Federal Energy Regulatory Commission

[Docket Nos. RM12-6-000 and RM12-7-000; Order No. 773]

Revisions to Electric Reliability Organization Definition of Bulk Electric System and Rules of Procedure

ACTION: Final rule.

Figure 1
Two Radial Systems Eligible for Exclusion E1

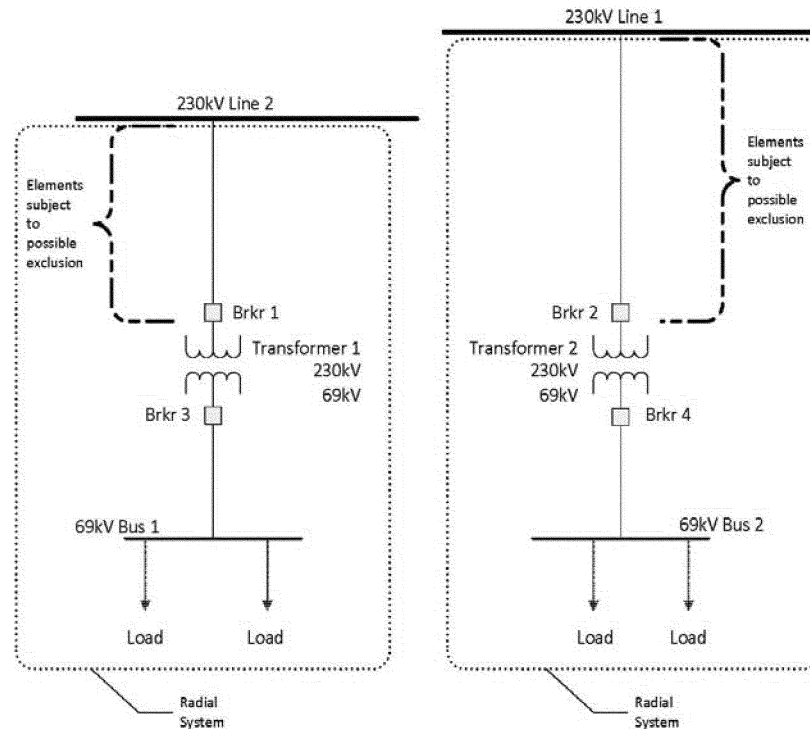
135. NERC and other commenters state that both radial systems depicted in figure 1 would be subject to exclusion E1(a) because they each only serve load.¹²⁶ ELCON agrees with NERC adding that these types of radial systems pose no reliability risk to the interconnected transmission network if the system is lost due to a fault condition. Similarly, SoCal Edison states that the figure 1 facilities would either be excluded or not part of the bulk electric system. SoCal Edison asserts that, because transformers 1 and 2 each have secondary voltages that are less than 100 kV, they do not meet the inclusion I1 requirements and, thus, are not included in the bulk electric system. In other words, SoCal Edison believes exclusion E1 should exclude all radial facilities that are greater than 100 kV up to the point where “the system is no longer radial, as indicated in figure 1 by the brackets where the 230 kV lines meet [lines 1 and 2].”¹²⁷ APPA believes that all the scenarios described by the Commission could create reliability concerns “if taken in isolation and operated in a certain matter” and

136. Anaheim agrees that the radials shown in figure 1 should be excluded and requests clarification that the associated bus work and protection system equipment installed on those radial lines are also excluded. Anaheim advocates that the exclusion should also apply to protection system equipment on the excluded facilities that provide backup protection for devices that are part of the bulk electric system, i.e. lines 1 and 2 in figure 1.

140. The Commission agrees with NERC that the radial systems shown in figure 1 meet the definition of “radial system” in exclusion E1. This configuration would result in the 230 kV lines between transformers 1 and 2 to the two 230 kV lines, respectfully, being excluded from the bulk electric system. The Commission agrees with NERC and other commenters that both radial systems depicted in figure 1 would be subject to exclusion E1 condition (a) because they each only serve load.

Figure 2
Networked Configuration w/115 kV Loop

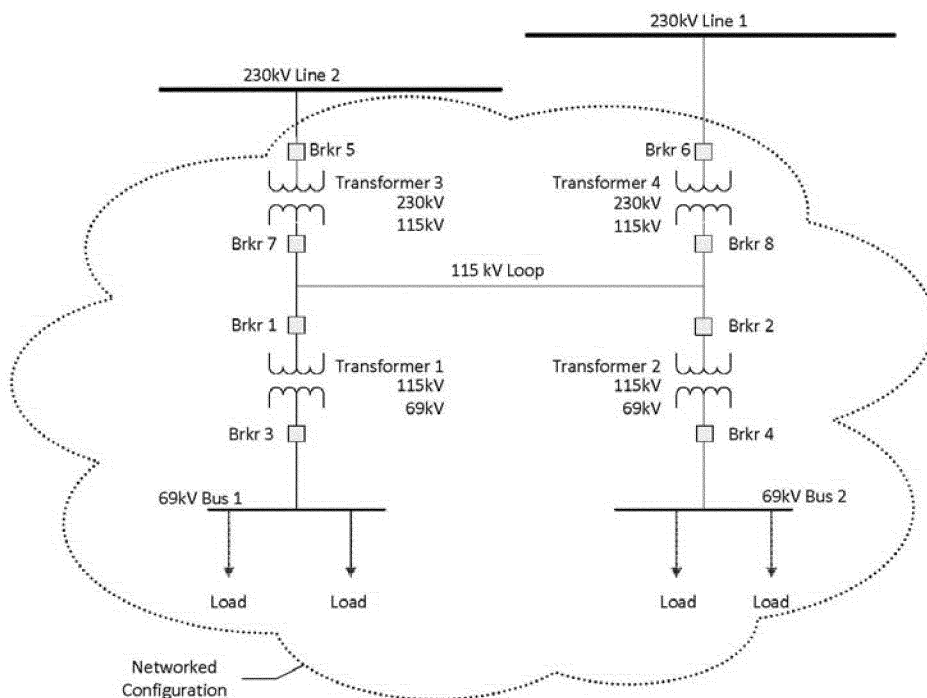
144. In the NOPR, the Commission requested comment on the scenario shown in figure 2 which shows a 115 kV loop, with the configuration emanating from two points of connection of 100 kV or higher. Specifically, the Commission requested comment on whether “the 115 kV and 230 kV elements above Transformers 1 and 2 to the points of connection to the two 230 kV lines would be excluded from the bulk electric system pursuant to exclusion E1.”¹³⁰ The Commission asked for comment on whether it is more appropriate to analyze figure 2 pursuant to the “local network” exclusion E3 and, if so, what if any elements operated at or above 100 kV would be excluded pursuant to exclusion E3.

145. NERC states that figure 2 is a non-radial loop on the 115 kV system. According to NERC, the 115 kV elements above transformers 1 and 2 to the point of interconnection with lines 1 and 2 would not be eligible for exclusion E1 because they do not emanate from a single point of connection. NERC also states that it would be appropriate to evaluate figure 2 under exclusion E3 as a potential local network.¹³¹ For such a candidate local network to qualify for exclusion, NERC states that additional technical analysis is needed to determine if all the exclusion E3 criteria are satisfied.¹³² NERC asserts that without such a technical analysis, the 115 kV elements above transformers 1 and 2 should be considered part of the bulk electric system.

146. Likewise, Idaho Power, ITC Companies, and National Grid contend that the figure 2 configuration should be included in the bulk electric system. Southern Companies believe exclusion E1 may apply from the breakers down and that the configuration may belong to

exclusion E3. AEP assumes that each of the facilities below the 115 kV loop shown in figure 2, and including breaker 1 and breaker 2, are radial and excluded pursuant to exclusion E1. According to AEP, the facilities above breakers 1 and 2 may be excluded pursuant to exclusion E3 depending on the circumstances.¹³³

147. Valero states that the figure 2 configuration is very similar to common facilities configurations employed in many industrial facilities involving the interconnection of the industrial facility to the utility through two high voltage feeder lines that originate at different utility owned and operated substations. Valero requests that the Commission include in the final rule an additional exclusion that would “categorically exclude from the [bulk electric system] any on-site high voltage switchyard facilities (less than 300 kV) owned by the industrial end-user where the predominant function of the facilities is to distribute electricity in an inward direction to the end-user’s load.”¹³⁴ WPPC argues that figure 2 shows both radial and network systems and that the system from the 115 kV loop upwards would be assessed under exclusion E3

148. The Commission affirms NERC’s statement that figure 2 is a non-radial loop and thus would not be eligible for exclusion E1 because it does not emanate from a single point of connection. The Commission agrees with commenters that the elements below the 115 kV loop should be assessed as two separate radial systems pursuant to exclusion E1. The remaining elements (the 115 kV loop, transformers 3 and 4 and the 230 kV tie lines above the transformers to the two 230 lines 1 and 2) should be assessed pursuant to exclusion E3 and if the configuration meets the criteria of exclusion E3, the elements could be excluded.

Figure 3
Networked Configuration w/69 kV Loop

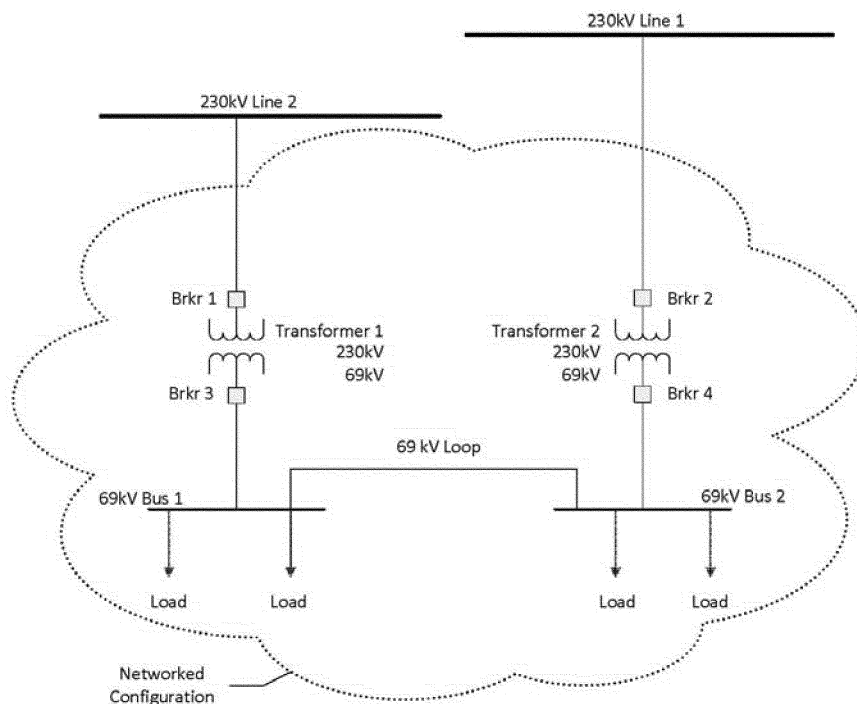
151. NERC disagrees with the Commission's characterization of figure 3 in the NOPR. NERC states that figure 3 does not depict a configuration with two points of 100 kV or higher or a system emanating from two points of connection at 230 kV. According to NERC, except for lines 1 and 2, all the other elements depicted in figure 3 are excluded from the bulk electric system. NERC explains that the elements between line 1 and transformer 2 and from line 2 to transformer 1 are excluded by exclusion E1(a) because "each separate set of [e]lements [described above] is contiguous and emanate from a single point of connection of 100 kV or higher."¹³⁷

153. Exelon agrees with NERC and explains that it has many connections similar to the one shown in figure 3 and provides a specific example where a 138 kV substation is fed by two radially connected 138 kV lines which in turn are connected through 40 MVA transformers to a 12 kV bus section. Exelon states that in its example the 40 MVA transformers cross bus sections so that if one of the 138 kV lines is out of service, each side of the 12 kV bus retains service. Exelon believes that due to the high impedance of the transformers, little energy flows between the buses in Exelon's

154. Other commenters believe that the figure 3 configuration may not be eligible for exclusion E1. SoCal Edison explains that the 69 kV loop is not open and therefore is a parallel path to the 230 kV system. BPA, Alameda and WREA do not view the figure 3 system as eligible for exclusion E1 because the system is networked. Idaho Power states that the 230 kV lines would be included only if there is a protection system in place for the 230 kV lines. According to Idaho Power, the elements above the transformers in figure 3 would not be excluded from the bulk electric system. Idaho Power believes this configuration should be evaluated under exclusion E3.

155. The Commission finds figure 3, which is identical to figure 5, is a networked configuration through a 69 kV loop and does not qualify for exclusion E1. The Commission also finds that, because the load in figure 3 can be served by either 230 kV line, it does not depict a “radial system.” However, the facilities below 100 kV may or may not be necessary for the operation of the interconnected transmission network, and this decision can be made case-by-case in the exception process. In other words, such facilities below 100 kV depicted in figure 3 would be excluded under the general threshold of the core definition unless found on a case-specific basis as necessary for the reliable operation of the interconnected transmission network. Thus, the Commission, while disagreeing with NERC’s interpretation, does not propose to include the below 100 kV elements in figure 3 in the bulk electric system, unless determined otherwise in the exception process. Further, as we discuss below in connection with exclusion E3 and figure 5, while we find that the configuration shown in figures 3 and 5 would not be eligible for exclusion E1, we believe that such configurations should be eligible for exclusion E3 for local networks. However, exclusion E3 as written requires the candidate local network to be contiguous and above 100 kV, thus, the exclusion E3 language as written does not allow for figures 3 and 5 to be eligible for the local network exclusion

because they are not contiguous *and* include facilities that are not above 100 kV. Therefore, we direct NERC to modify exclusion E3 to remove the 100 kV minimum operating voltage in the local network definition. This modification will enable configurations similar to figures 3 and 5 to be assessed for the local network exclusion. The Commission believes this modification, together with satisfying the criteria outlined in exclusion E3, will appropriately exclude local network configurations that are not necessary to the reliable operation of the interconnected transmission network.¹³⁹

Figure 5
Networked Configuration w/69 kV Loop

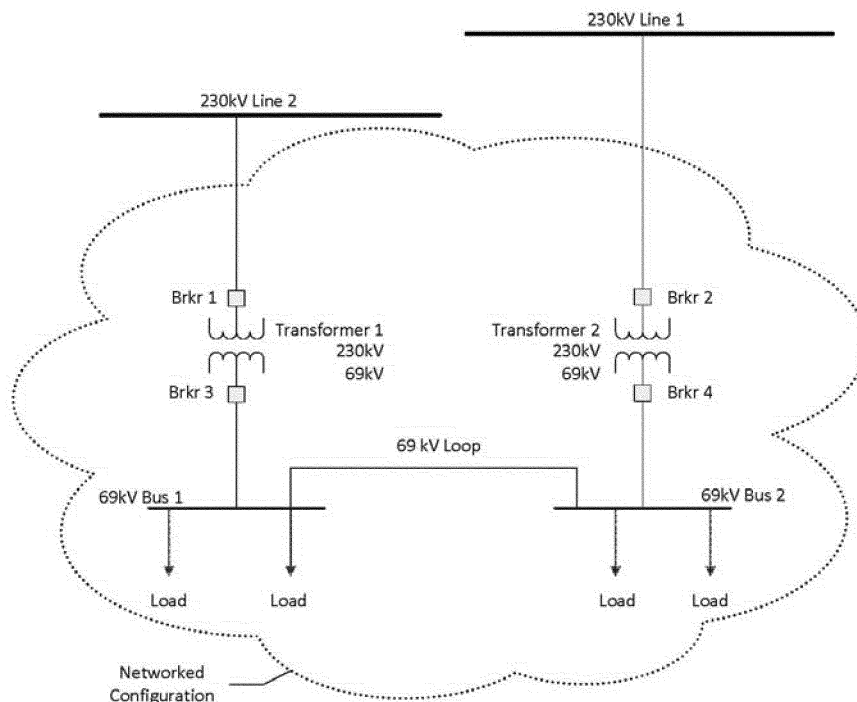
195. In the NOPR, the Commission stated that figure 5 depicts a group of elements that are contiguous through a 69 kV loop and requested comment whether the configuration in figure 5 qualifies as a local network and, in particular, whether the configuration satisfies the conditions that a local network be contiguous and operated at or above 100 kV.

196. NERC views figure 5 the same as figure 3—as a looped system below 100 kV—that is not considered under this exclusion because the elements below 100 kV are presumed to be not part of the bulk electric system.¹⁶⁷ NERC maintains that, if it is determined that the sub-100 kV looped system is necessary for the reliable operation of the interconnected transmission network, the exception process may be utilized to include the appropriate elements. NERC states that figure 5 depicts two separate and distinct groups of elements that each emanate from a

197. Exelon states that the clear intent of the definition is that configurations such as shown in figure 5 are radial systems subject to exclusion E1 (radial systems). According to Exelon, had this not been the intent of exclusion E1, exclusion E3 would have allowed for a local network where the tie was below 100 kV to avoid a reliability gap. Exelon believes that the configuration shown in figure 5, which is identical to figure 3, does not qualify as a local network within the terms of exclusion E3 and supports NERC's view that figure 5 represents two radial systems that qualify under exclusion E1. Exelon cautions that, if the Commission determines that the systems depicted in figure 5 do not qualify under exclusion E1 because of the low voltage tie and does not qualify under exclusion E3 because the tie is at low voltage and not a 100 kV or above, such a decision would leave a gap under which a substantial number of facilities that are not part of the bulk electric system

would be classified as such. Exelon states that it would have to go through the separate exception process for dozens of substations, at great cost and for no useful purpose. Exelon states that the Commission should clarify that the configuration shown in figures 3 and 5 qualifies as a radial system and is excluded pursuant to exclusion E1.

199. As discussed above, the Commission is directing a modification to exclusion E3 to better capture local networks like those depicted in figure 5. The Commission notes that Exelon believes that the configuration shown in figure 5, which is identical to figure 3, does not qualify as a local network within the terms of exclusion E3. While figures 3 and 5 are a networked configuration through a 69 kV loop, they do not qualify for the local network

exclusion because exclusion E3 defines local networks as “[a] group of contiguous transmission Elements operated at or above 100 kV but less than 300 kV that distribute power to Load rather than transfer bulk-power across the interconnected system.” The configuration in figure 5 includes elements that are below 100 kV, and does not have contiguous elements operating at or above 100 kV but less than 300 kV. As noted above, while the Commission finds that these configurations should not be eligible for exclusion E1, we believe that they should be eligible for the local network exclusion. Therefore, we direct NERC to modify exclusion E3 to remove the 100 kV minimum operating voltage in the local network definition. Within 30 days of the effective date of this Final Rule, we direct NERC to submit a schedule outlining how and when it will make the modification to the definition.
